PCN#20180327000
Conversion to smaller reel (13" to 7") and associated packing materials
on Select Devices currently shipped in 13" reels
Final Change Notification

Date: April 25, 2018
To: TOKYO ELECTRON DEVICE (DSTR) PCN

PCN Number:	20180327000	PCN Date:	April 17, 2018
Title:	Conversion to smaller reel (13" to 7") and associated packing materials on Selected Devices currently shipped in 13" reels		
Customer Contact:	PCN Manager	Dept:	Quality Services
Proposed 1st Ship Date:	July 17, 2018		
Change Type:			
☐	Assembly Site	☐	Assembly Process
☐	Design	☐	Electrical Specification
☐	Test Site	☒	Packing/Shipping/Labeling
☐	Wafer Bump Site	☐	Wafer Bump Material
☐	Wafer Fab Site	☐	Wafer Fab Materials
		☐	Part number change

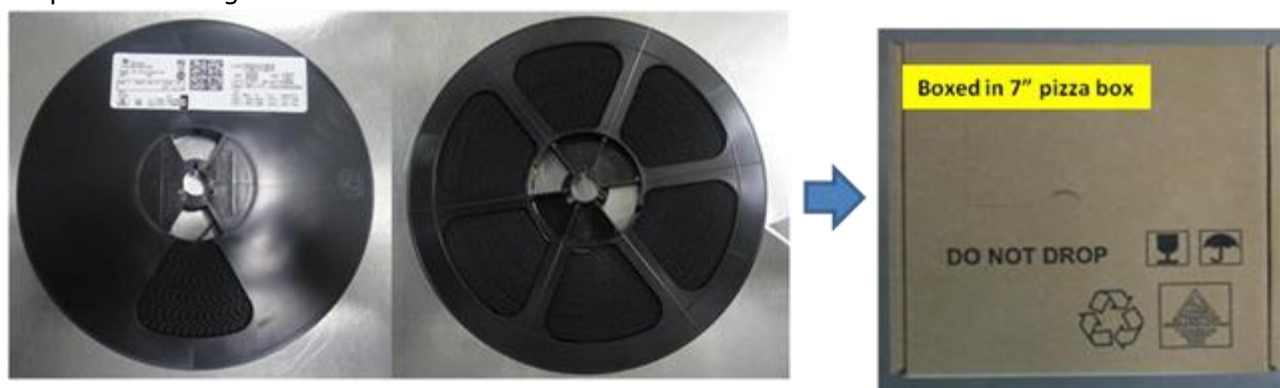
Conversion to a smaller reel size for selected product currently shipped in 13" reels with small reel quantities. The Moisture Barrier Bag (MBB) and pizza box will be switched to accommodate the smaller reel size. All new packing materials are qualified and currently in use for other products. Pack material differences are shown below:

Current Packing – 13 inch reel diameter

Proposed Packing – 7 inch reel diameter

Pack BOM	From	To
Reel Diameter	13"/4220831	7"/4203839
Pizza Box	4207162	4206831
Pack Filler	4208630	4221303

Quality improvement. There has been reported quality issues with reels shipped with less than half full of product causing reel deformation.
